TRANS/WP.29/GRSP/2002/10
7 March 2002

World Forum for Harmonization of Vehicle Regulations (WP.29)

PROPOSAL FOR DRAFT AMENDMENTS TO REGULATION No. 44

Transmitted by the Expert from the Netherlands

Figure 1
Arrangement for testing a forward-facing device"

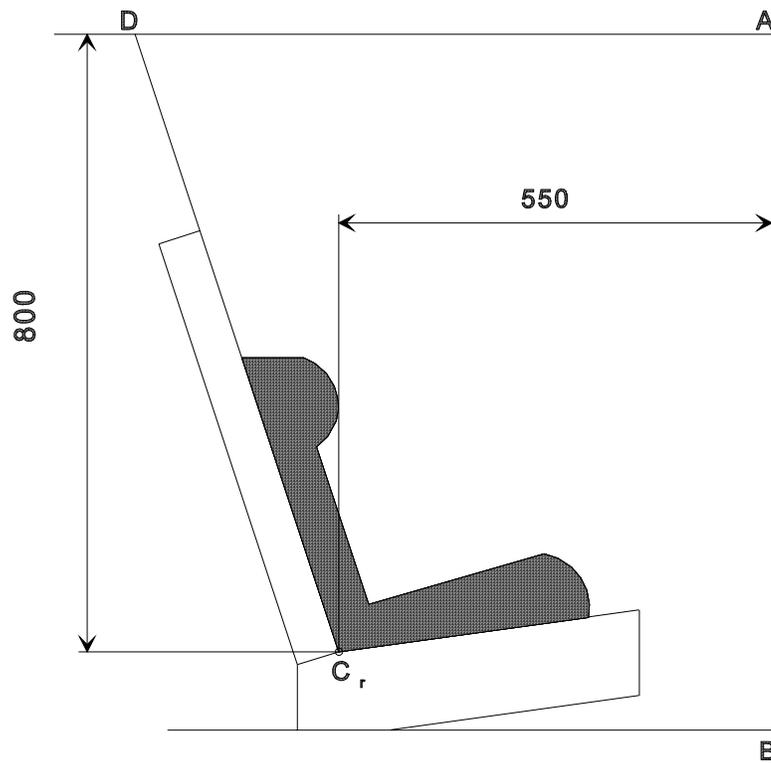
Paragraph 7.1.4.4.1.1., amend to read (the cursive text has been added):

"7.1.4.4.1.1. Forward facing child restraints: the head of the manikin shall not pass beyond the planes BA and DA as defined in Figure 1 below. This shall be judged up to 300 ms or the moment that the manikin has come to a definitive standstill *whatever occurs first*.

Figure 2:
Arrangement for testing
a rearward-facing device

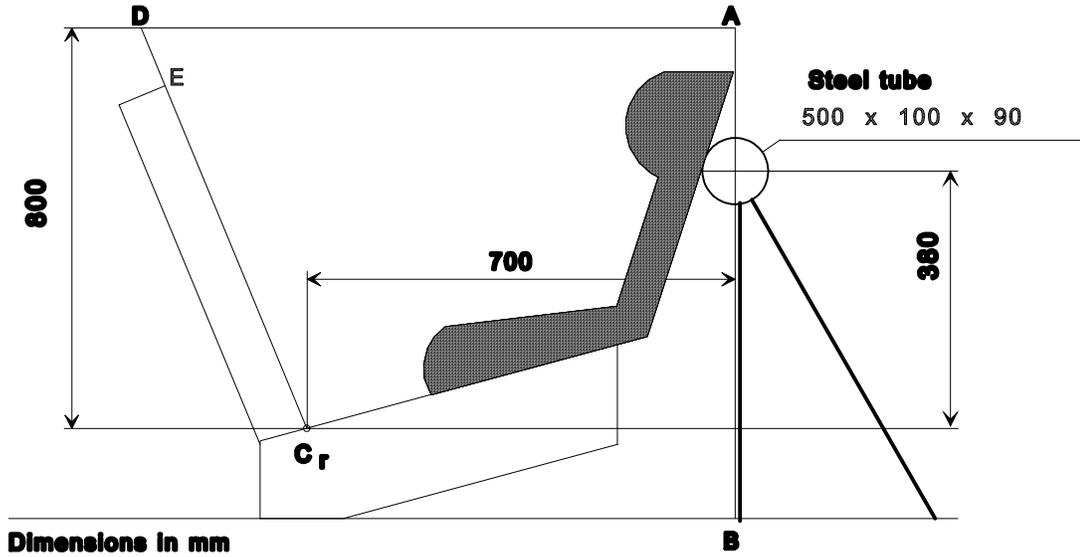
Paragraph 7.1.4.4.1.2.1., amend to read:

"7.1.4.4.1.2.1. Child restraints supported by dashboard: the head of the manikin shall not pass beyond the planes AD and DCr, as defined in Figure 2 below. This shall be judged up to 300 ms or the moment that the manikin has come to a definitive standstill whatever occurs first.

Paragraph 7.1.4.4.1.2.1., insert the reference to the plane "AB" before to the reference to the plane "AD".

Figure 3

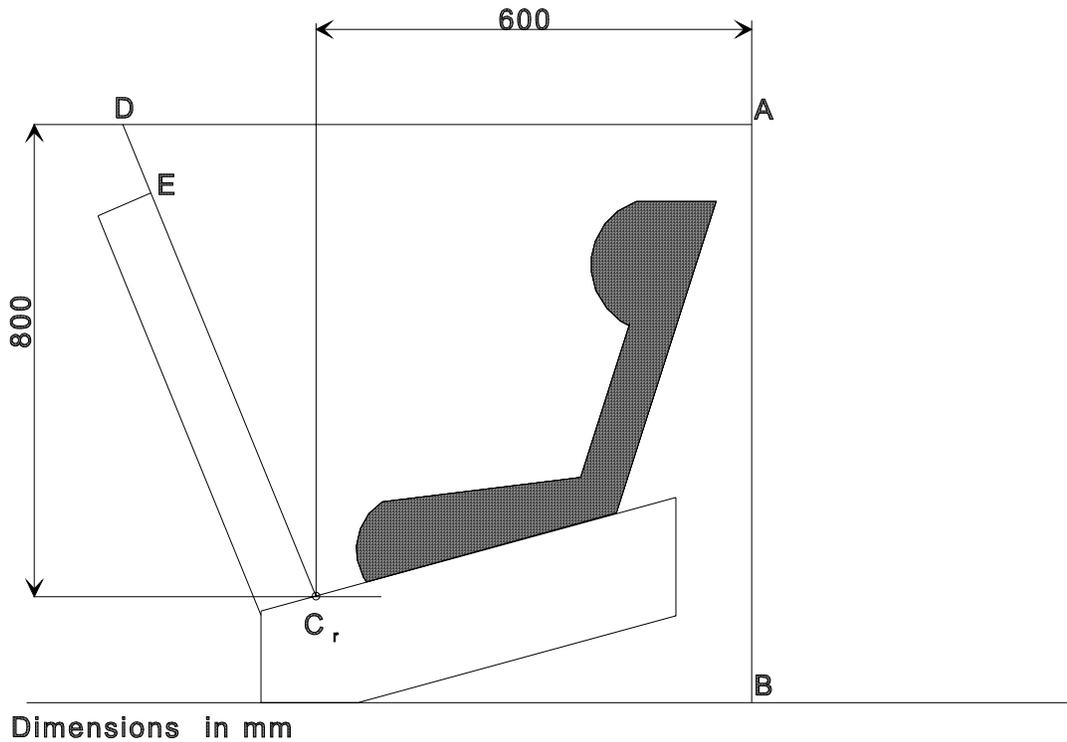
Paragraph 7.1.4.4.1.2.2., amend to read:

"7.1.4.4.1.2.2. Child restraints in group 0 not supported by the dashboard, and carrycots: the head of the manikin shall not pass the planes AB, AD and DE as shown in Figure 3 below. This shall be judged up to 300 ms or the moment that the manikin has come to a definitive standstill *whatever occurs first*.

Figure 2

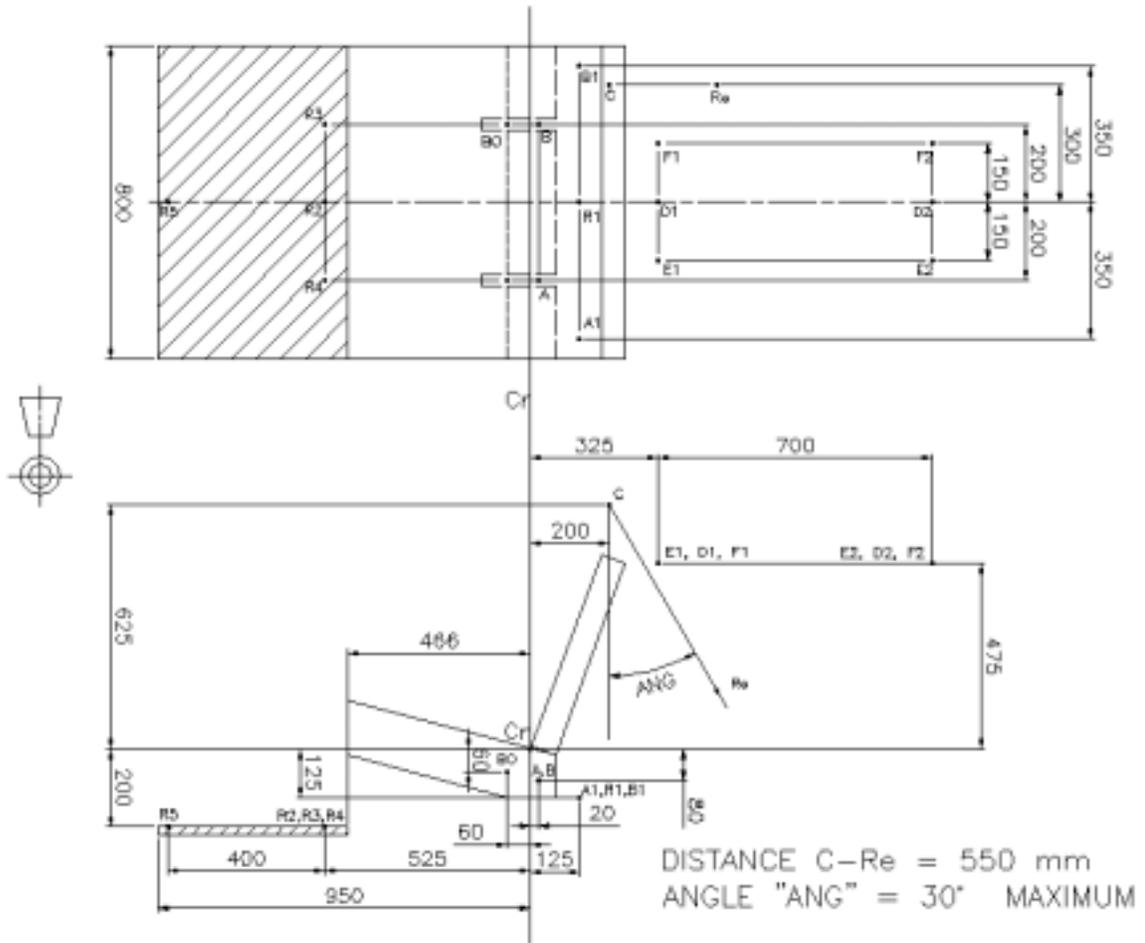
Insert new paragraphs 3.3 to 3.3.1.5., to read:

- 3.3 Trolley floor pan
- 3.3.1. The floor pan of the trolley shall be constructed of a flat sheet of metal of uniform thickness and material , see figure 2 of appendix 3 to this annex.

- 3.3.1.1. The floor pan shall be rigidly intermittent welded or bolted to the corresponding trolley structure.
- 3.3.1.2. The floor pan shall be designed so that the surface hardness should not be below 120 HB, according to EN ISO 6506-1:1999.

- 3.3.1.3. The floor pan shall withstand an applied vertical concentrated load of 5 kN without causing a vertical movement greater than 2 mm referring to Cr and without any permanent deformation occurring.

- 3.3.1.4. The floor pan shall have a surface roughness not exceeding Ra 6,3 according to ISO 4287:1997.
- 3.3.1.5. The floor pan shall be designed so that no permanent deformation is occurring after a dynamic test of a child restraint system, according to this Regulation.
